**Economic and Social Council**Distr.: General
1 April 2014

Economic Commission for Europe**Inland Transport Committee****World Forum for Harmonization of Vehicle Regulations****163rd session**

**1958 Agreement – Consideration of draft amendments
to existing Regulations submitted by GRPE****Proposal for the 01 series of amendments to the draft
Regulation on uniform provisions concerning the approval of
Retrofit Emissions Control (REC) devices for heavy duty
vehicles****Submitted by the Working Party on Pollution and Energy ***

"Annex 4

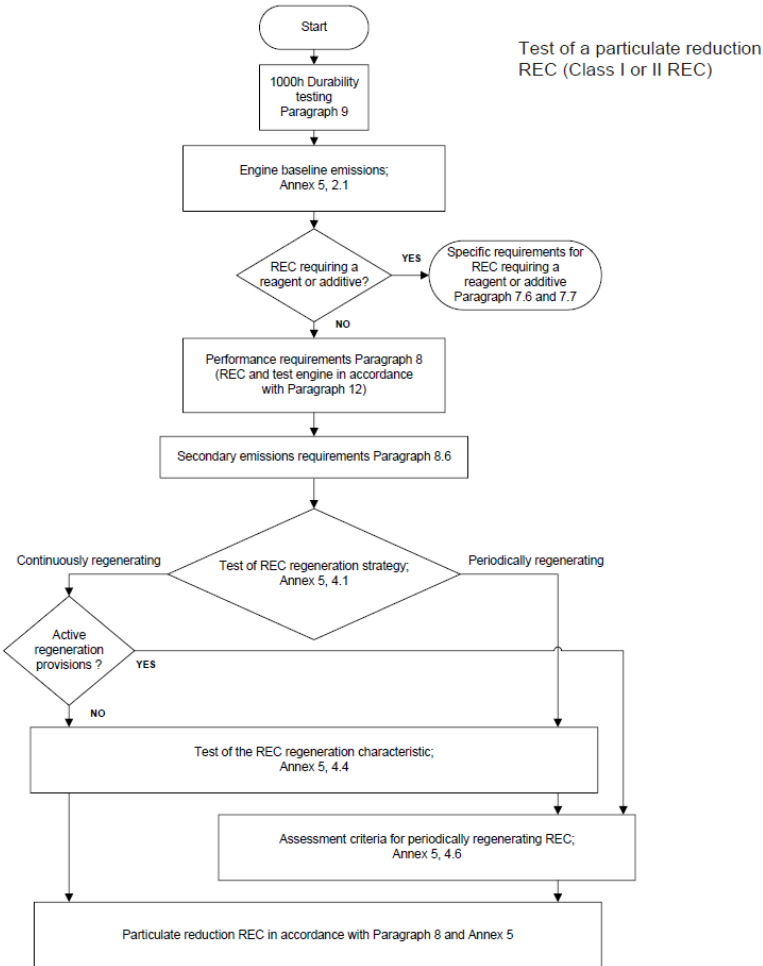
Annex 4, amend to read:

The above example type-approval mark affixed to a REC shows that the type concerned has been approved in the Netherlands (E 4), pursuant to Regulation No. [nnn] under type-approval No. 011234. The first two digits of the type-approval number indicate that the approval was granted in accordance with the requirements of Regulation No. [nnn] in the form amended by this series. The approval mark shall also show the Class of REC (I, IIA, IIB, III or IV)."

"Annex 8

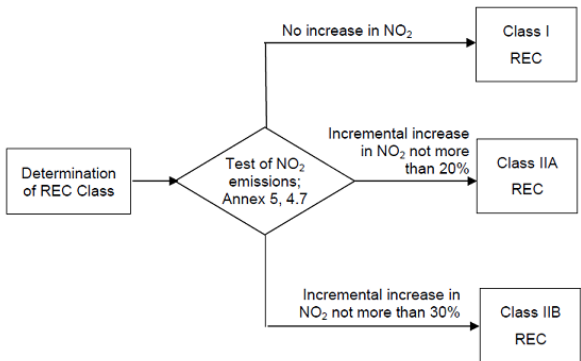
Annex 8, amend to read:

1. Test sequence for particulate reduction REC

Determination of the REC Class
